To: T10 Technical Committee
From: Robert Sheffield, Intel (robert.l.sheffield@intel.com)
Date: 28 October 2004
Subject: 04-357r0 SAS-1.1: Another Port Selector Detection Gap

Overview

Figure 85 — SP (phy layer) state machine - OOB sequence states

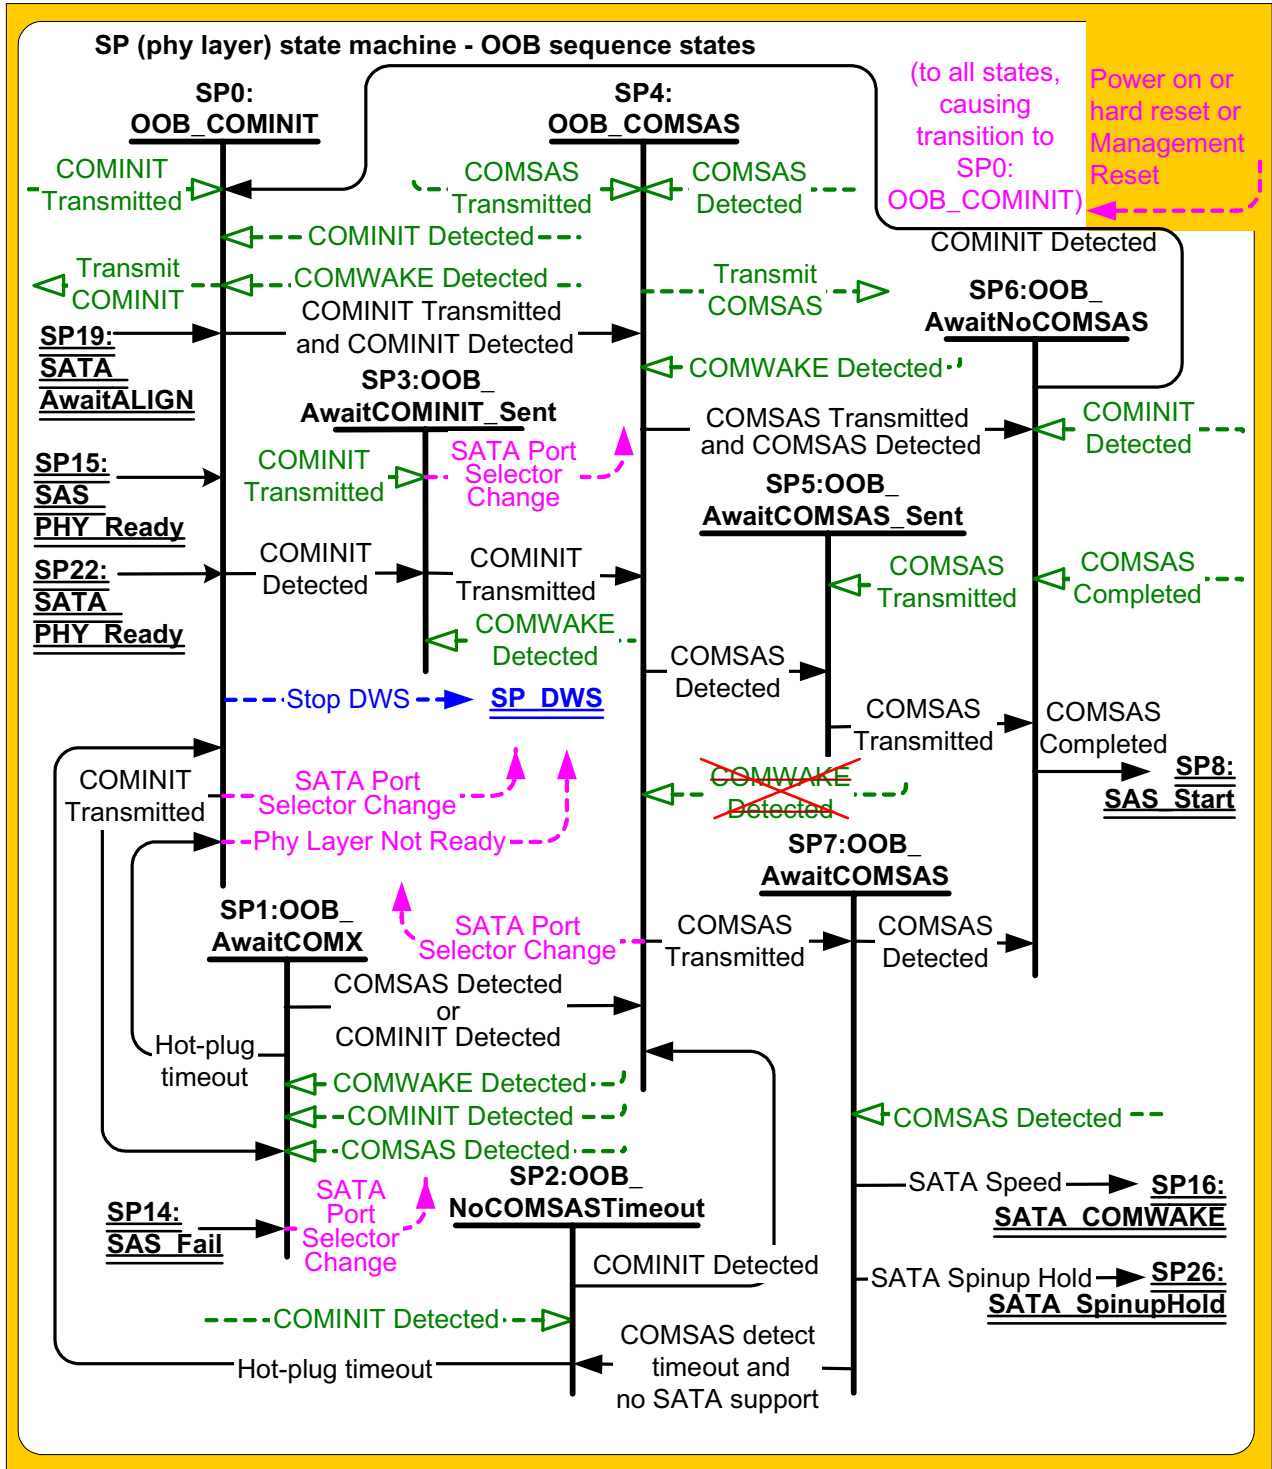
This proposal also includes an editorial change to Figure 85 - SP (phy layer) state machine - OOB sequence states to remove a duplicate incoming message, COMWAKE detected, in SP4:OOB_COMSAS.
